PRE-APPLICATION RESPONSE CONT.

Pre-Application & Response

Chris Dyson Architects intends to sympathetically restore a Grade II listed building. The living space would be thoughtfully upgraded, whilst retaining and enhancing the legibility of the historic building. We would also like to sensitively restore and upgrade the ground floor room.

A sketch of the proposed rear extension at the preapplication phase.

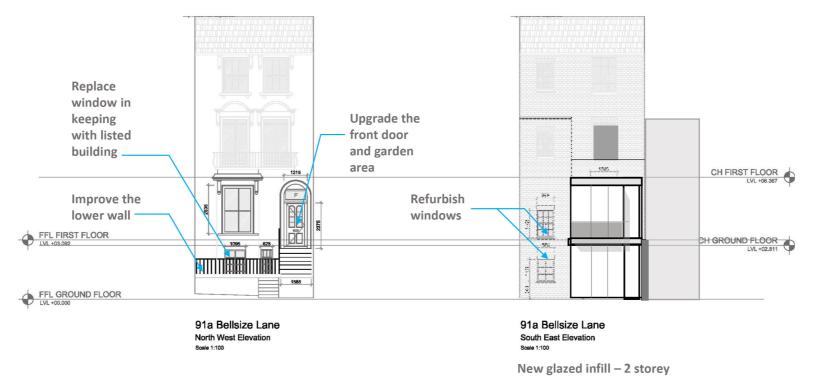
- "Although the concept of a contrastingly lightweight extension is seen as an appropriate way forward, concerns are raised about the two storey nature of the proposed extension, which is seen to be contrary to the Council's CPG on rear extensions as there is a danger the extension will not read as subservient to the host building and wider terrace due to its height, depth, footprint and resultant bulk."

- 2 "Current guidance also advises that rear extensions should normally be subservient to the existing building line, and not project beyond it. It is noted that in this case that the neighbouring conservatory, likely to be some 20 to 30 years old, does project further into the garden, but this was allowed prior to current guidance."

- 3 "Moreover, the current proposals involve the loss of large areas of original external brick wall together with a number of original window and door openings is a fundamental concern regarding the design principles behind the extension."

4 "Furthermore, it would seem that the design is striving to incorporate too much accommodation into the building by providing bedroom and living accommodation at both levels of the extension which traditionally would occupy space within the main areas of the existing building."

The extension proposed is subservient to the host building by respecting the existing building line and its proportions. The guidance in question (Camden Planning Guidance: Design, CPG1) is not prescriptive on height. Instead, height should respect the pattern of surrounding development, be subordinate and respect the design of the building. CDA believes that that latest scheme respects the host building.

The proposal occupies the infill between the closet wing and the boundary wall. The glazing is pulled back, sitting just behind the existing building line and not protruding into the garden, unlike most of the extensions on adjacent properties in the listed terrace. Additionally, the light pollution levels on this property are confirmed as being less than those of the neighbouring buildings.

CDA is responding by proposing a scheme that is closley aligned with the original footprint and intent of the building. Unlike the schemes put forward in the pre-application, the latest scheme keeps most interior partitions, door, and window locations intact. The boldest intervention involves keeping the original window locations and openings on the rear elevation. These openings extend to be extended to the finish floor. CDA believes that altered openings facilitate a seamless transition to the extension, all the while respecting the architectural intent of the building.

CDA believes that the room assignment and programming of the updated scheme is more aligned with the original intent of the building. As originally intended, the ground floor (arrival), is more grand, while the lower ground floor is more flexible and utilitarian. CDA is re-introducing a reception to the ground floor space, as well as re-introducing period appropriate cornicing, detailing and panelling.
